RECORD OF RECOMMENDATIONS, VOTING RECORDS, AND CONDITIONS OF APPROVAL

PLANNING CASE NO. SP2023-012

CONSTRUCTION PLANS FOR SCREENING AND BUFFERING

Comments on sheet L10 and L11

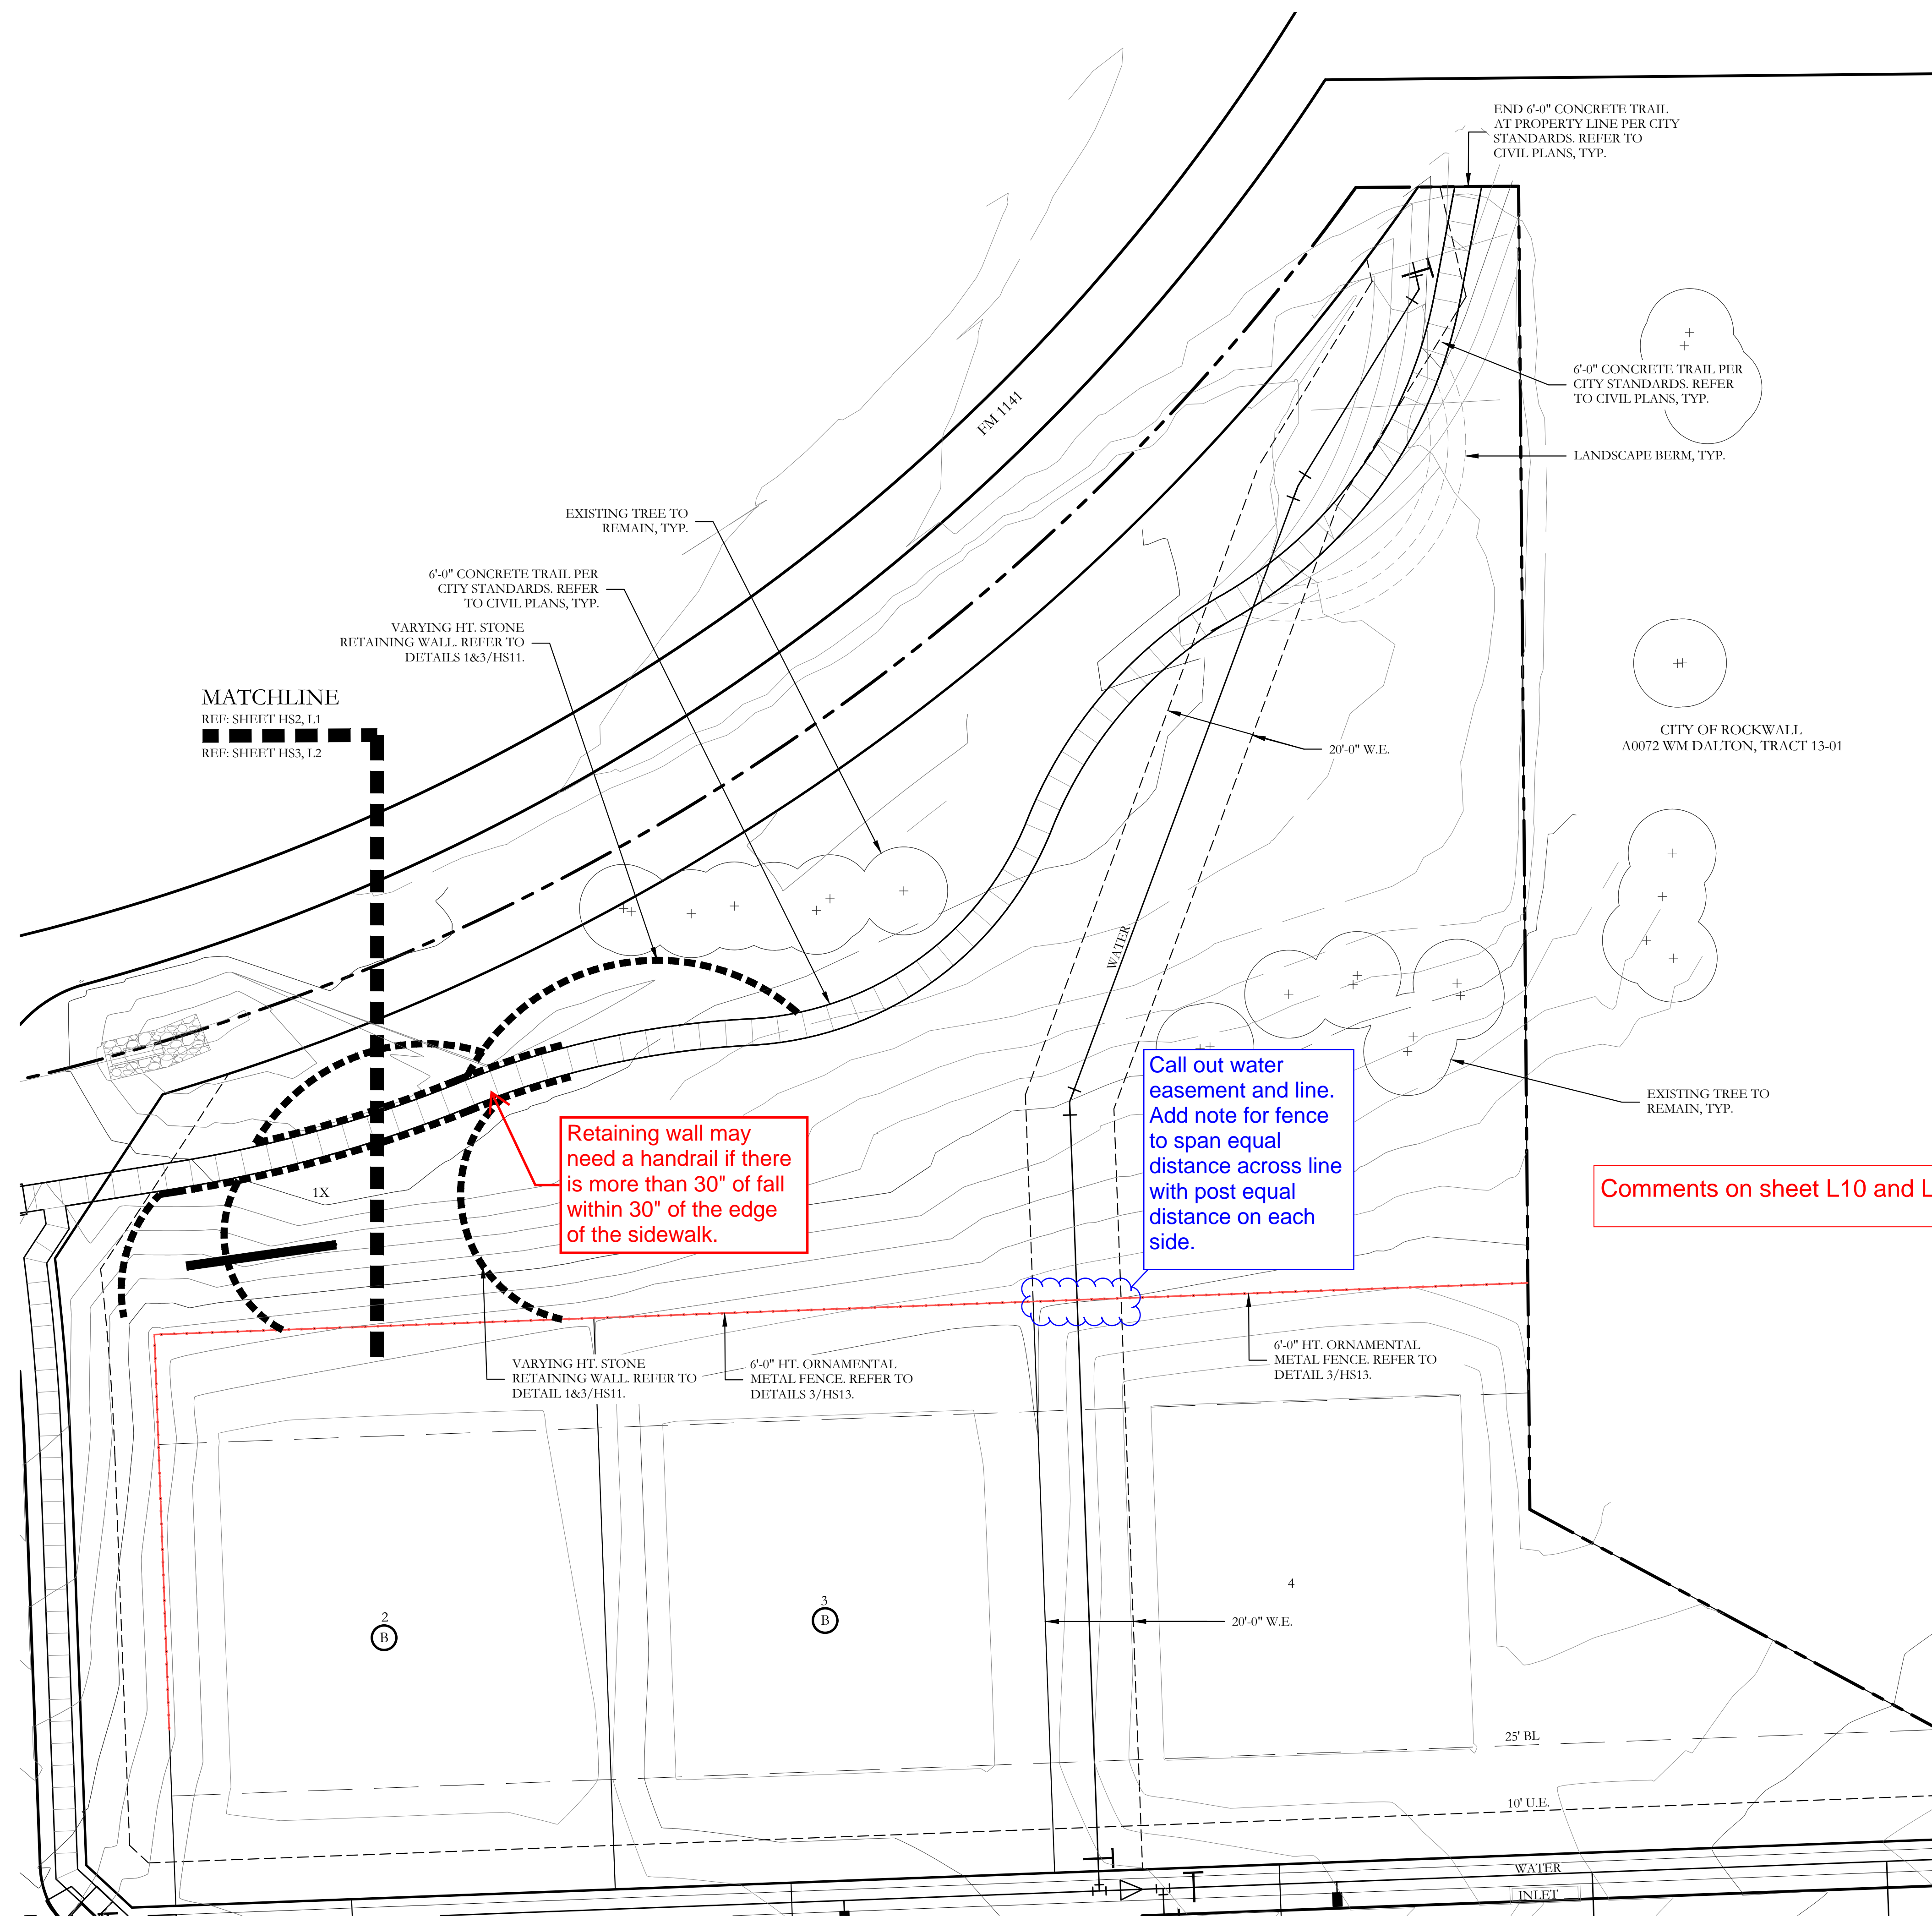
Should plan be submitted for the city park along Cornelius or noted on the plans about the City Park development with this development .
